Access Compliance Report Public Rights-of-Way (Curb Ramps)

Main Street: MAGNOLIA_DR		Cross Street: BLUE_SPRUCE_DR		Location:	W
ADA ID: RPAT211101144356	Ramp Type: Type 4 - Parallel	Initial Pass/Fail: Fail	Overall Compliance: No	Severity Score:	30
Codes/Mitigation Info/Possible Solution			Field Measurements/Component Compliance

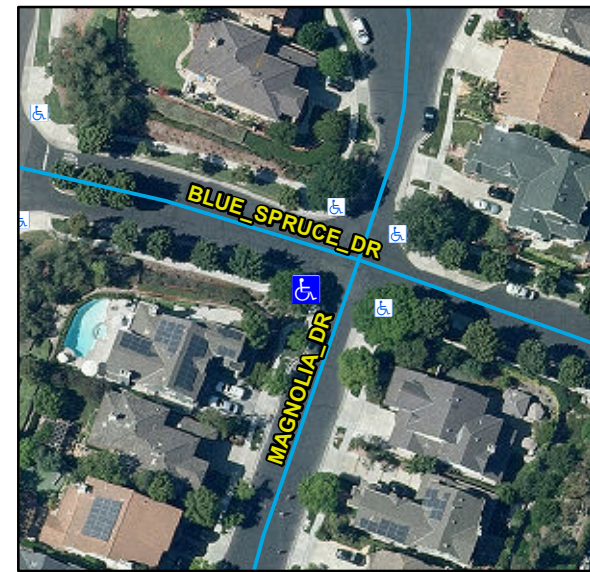
Compliance	Description	Data	Compliance	Description	Data
N/A	Ramp Length LT (in)	115	N/A	Ramp Length RT (in)	110
Yes	Ramp Width LT (in)	53	Yes	Ramp Width RT (in)	53
No	Ramp Run Slope LT (%)	13	Yes	Ramp Run Slope RT (%)	2.1
Yes	Ramp Cross Slope LT (%)	1	Yes	Ramp Cross Slope RT (%)	1.2
N/A	Landing Present	N/A	N/A	DWS Provided	N/A
N/A	Landing Length (in)	N/A	N/A	DWS Contrast	N/A
N/A	Landing Width (in)	N/A	N/A	DWS Length (in)	N/A
N/A	Landing Run Slope (%)	N/A	N/A	DWS Full Width	N/A
N/A	Landing Cross Slope (%)	N/A		DWS Offset Type	N/A
N/A	Landing Movement Obstructed?	N/A	N/A	DWS Offset Left (in)	N/A
	Landing Movement Type	N/A	N/A	DWS Offset Right (in)	N/A
N/A	Landing Shared	N/A			
N/A	Clear Space	Yes			
N/A	Clear Space To Crosswalk (in)	N/A			
N/A	Marked Crosswalk 1	No	N/A	Marked Crosswalk 2	No
	Crossing 1 Direction	SE		Crossing 2 Direction	NE
	Marked Crosswalk 1 Width (in)	N/A		Marked Crosswalk 2 Width (in)	N/A

N/A	Ramp Inside Crosswalk 1	N/A	N/A	Ramp Inside Crosswalk 2	N/A
	Crossing 1 Slope (%)	6.9		Crossing 2 Slope (%)	5.1
	Crossing 1 Cross Slope (%)	0.6		Crossing 2 Cross Slope (%)	6.5
N/A	Gutter Ponding	N/A	N/A	Curb Slope	5.4
Yes	Gutter Lip Height (in)	0		Road Run Slope (%)	5.7
N/A	Gutter Run Slope (%)	N/A		Road Cross Slope (%)	5.4
N/A	Gutter Cross Slope (%)	N/A	No	Perpendicular Joint Present	No
Yes	Overall Surface Condition	Acceptable			
	Cross Gutter Present?	No		Spandrel Present?	No
	Replace Cross Gutter?	N/A		Replace Spandrel?	N/A

Remove & Replace Curb Ramp With Two New Directional Ramps or Equivalent.

R204.3, R304.3.2, STD 1115
